WURLITZER SERVICE SLANTS

SUBJECT: Supplemental Adjustment Procedure - Record Arm Shaft Coupling.

AFFECTING: Model 3400 Series Phonographs.

FIG. 1

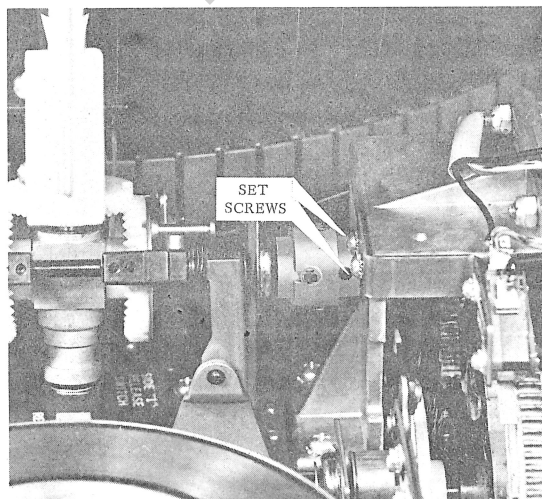
Loosen the two Coupling Set Screws illustrated in figure 1.

Tighten the two Coupling Set Screws illustrated in figure 1.

FIG. 2

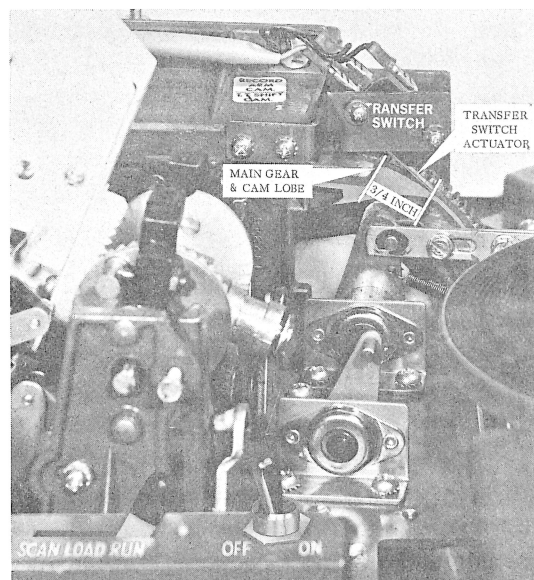
Turn the service switch off to stop the Main Gear and Cam when the Lobe is $3/4$ " from the end of the Transfer Switch Actuator as illustrated in figure 2.
